Title: TRACE-PAD INTERFACE FOR IMPROVED SIGNAL
QUALITY

Atty's Docket No.: 51636/142

PRELIMINARY AMENDMENT

Fig 1A Prior Art

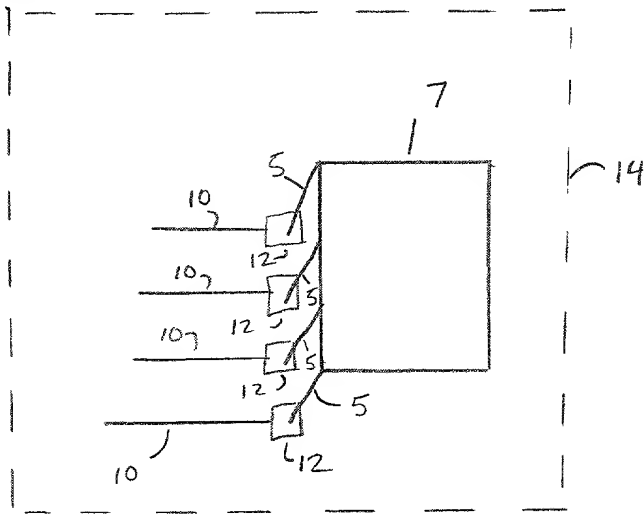
Figure 1A has been added. It shows a schematic diagram of the prior art. This is a diagram of a component 7 with multiple leads 5 on a printed circuit board 14. It shows a component 7 with multiple leads 5 connected to a pad 12 on the printed circuit board 14 as

described on page 1, lines 8-11. The pads are connected to traces 10 at 90° angles as is described on lines 13-19.

--Fig. 1A is a schematic diagram of a component on a printed circuit board as is in the prior art; --

Fig 1B

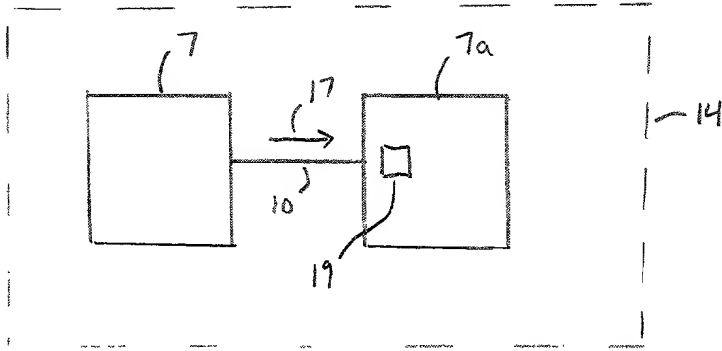
Figure 1B has been added. It shows a block diagram of two components, 7 and 7a, connected on a printed circuit board 14. The components are connected via a trace 10 as is described on page 1, lines 13-15. Digital signals 17 travel from component 7 to component 7a on printed circuit board 14 as is described on page 2, lines 2-4. The destination component 7a has an input receiver 19 which is triggered by the digital signal 17 as is described on page 2, line 4.

--Fig. 1B is a block diagram of two components connected on a printed circuit board; --

Fig 1C

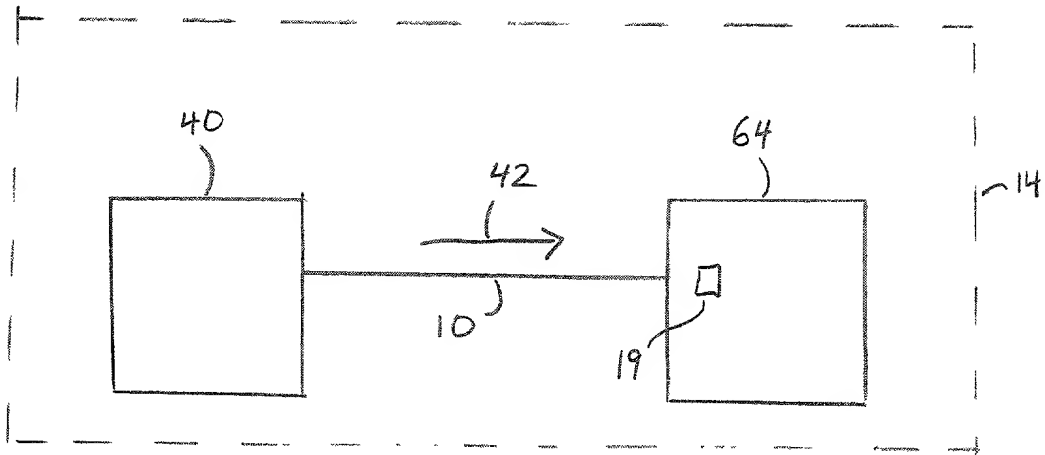
Figure 1C has been added. It shows a block diagram of a memory controller and memory as an example of two components connected on a printed circuit board. On page 2, lines 5-7, the memory controller and the memory are described as an example of the description on page 2, lines 1-5. Therefore, the diagram of Figure 1C is almost identical to that of Figure 1B, the diagram depicting the description of page 2, lines 1-5. Figure 1C has component 7 replaced by memory controller 40, digital signal 17 replaced by control signal 42, and component 7a replaced by memory 64. This is in accordance with the specific example described on page 2, lines 5-7.

--Fig. 1C is a block diagram of a memory controller and memory as an example of two components connected on a printed circuit board; --

Figure 7

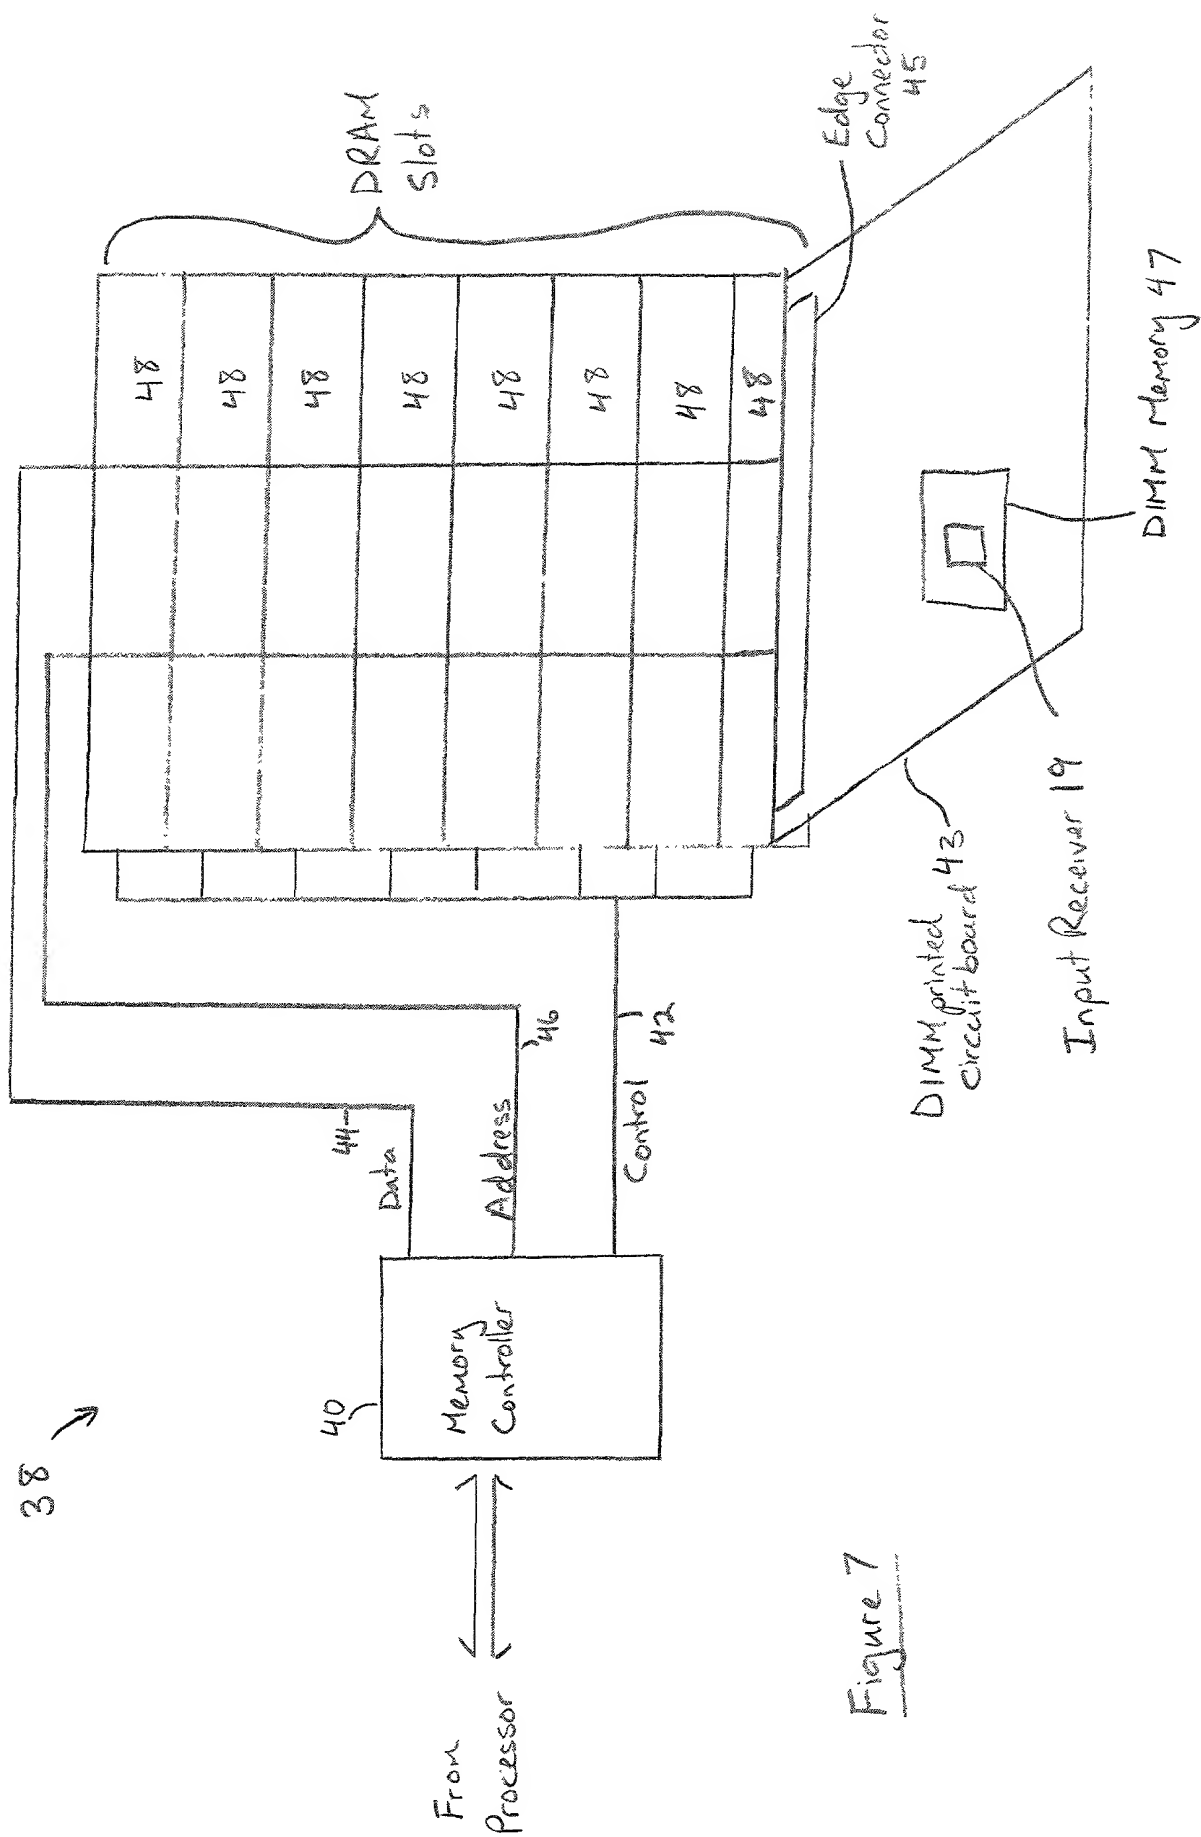
In Figure 7, a number of elements have been added. One such element is DIMM printed circuit board 43. The DIMM printed circuit board 43 is described on page 10, lines 14-15 as a separate printed circuit board where the DRAM DIMMs reside. DIMM printed circuit board 43 connects to slot 48 via an edge connector 45. The edge connector 45 was shown but previously unlabelled in Fig. 8. The edge connector is now labelled in Fig. 8 and is shown in Fig. 7. The

description on page 10, lines 13-14 shows how the DIMM is connected to DIMM slot 48. This has now been illustrated in Fig. 7 and described on page 10 after line 15. Another new element in Fig. 7 is DIMM memory 47 which resides on the DIMM printed circuit board 43. This is described on page 10, lines 14-15 and also lines 17-20 stating that the DIMM printed circuit board 43 is a separate printed circuit board than that containing the memory controller and that the DIMM memory 47 is contained on the DIMM printed circuit board 43. Combining Fig. 1C with the memory as described on page 10, lines 17-20 gives memory, in this case DIMM memory 47, with an input receiver 19, connected to memory controller 40 which sends control signals 42 to DIMM memory 47 via a trace. This has been illustrated in Fig. 7 in accordance with the description on pages 2 (as per Fig. 1C) and 10. As such, no new matter has been added with the amendment to Fig. 7.

On page 10, line 15, after "another circuit board" add --43. The DIMM printed circuit board 43 connects to slot 48 via an edge connector 45--.

FIG. 8

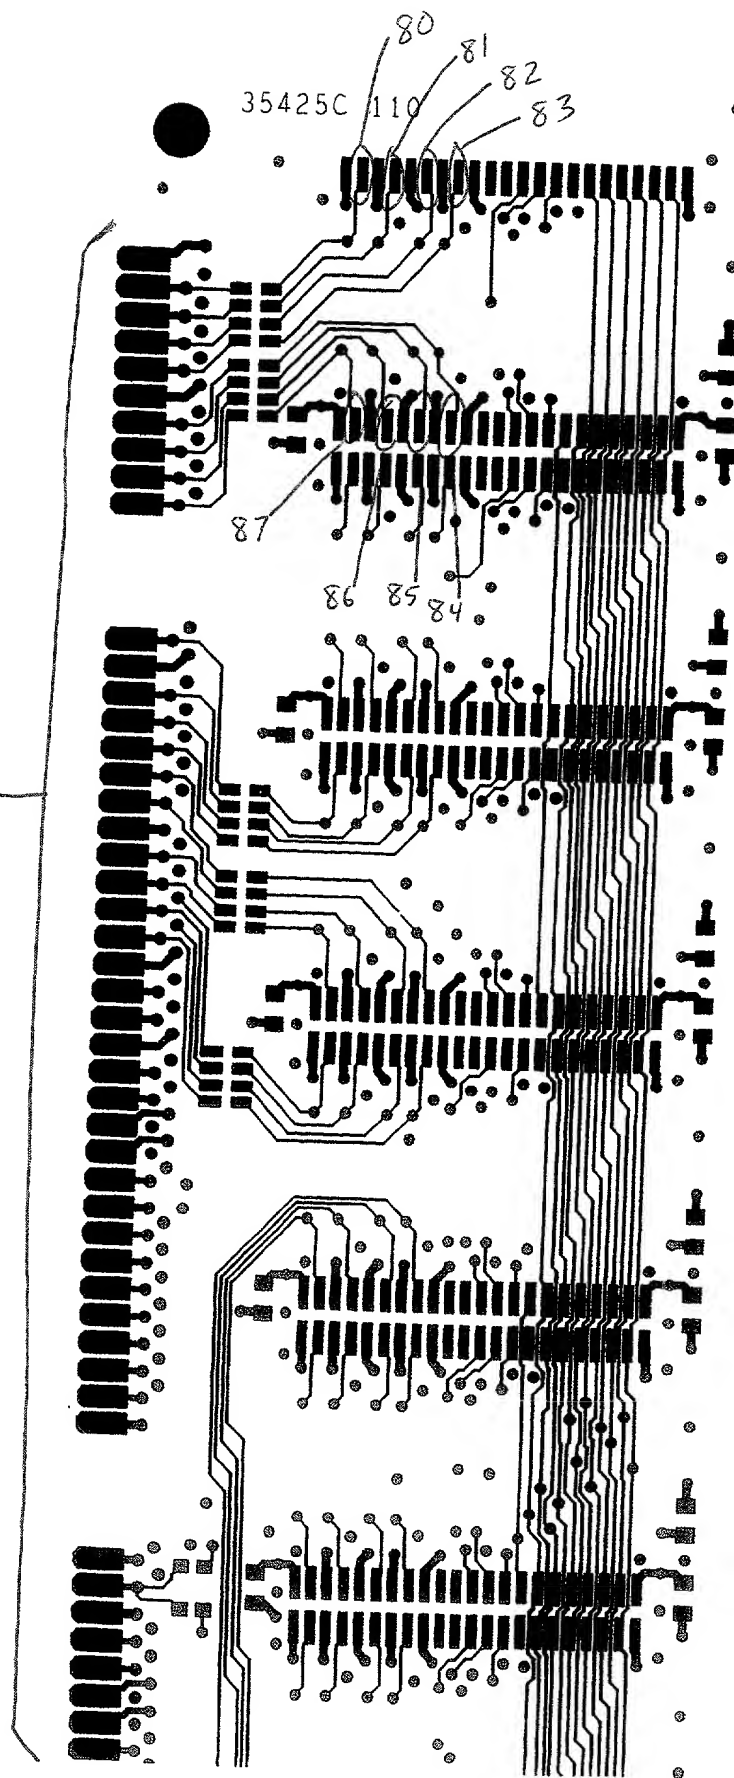
Fig. 8 has had reference numerals added to it. The drawing had been previously described on page 11, lines 4-6 as a DIMM printed circuit board made in the manner as described in the specification. As stated previously, the edge connector that was previously shown in Fig. 8 has now been identified by means of a reference numeral. The definition of a dual-in-line memory module (DIMM) was downloaded from *IT Windows Library*, produced by Penton Media Inc., <http://windowsitlibrary.com/Content/175/02/7.html> on December 12, 2000. A copy of this website is attached. It defines a DIMM as a "RAM package that holds several memory chips on a single circuit board and has a 168-pin single-row edge connector for insertion into the motherboard". An edge connector is an inherent part of a DIMM and was shown in the original Figure 8. The existence of a memory chip or component attached to the printed circuit board is also inherent in the structure of the DIMM. Areas 80-87 that can be seen to have the structure of the invention as is shown in Figure 4 have been marked. An explanation of this has been added

on page 11. As this is an explanation of the definition and inherent structure of the DIMM, this is not new matter.

--Referring to Fig. 8, the edge connector 45 attaches the DIMM printed circuit board to the printed circuit board containing the memory controller. The DIMM memory components attach to the DIMM printed circuit board. As can be seen from Fig. 8, areas 80-87 have the connect structure of the pads with the traces as described in the invention and as shown in Fig.

4.--
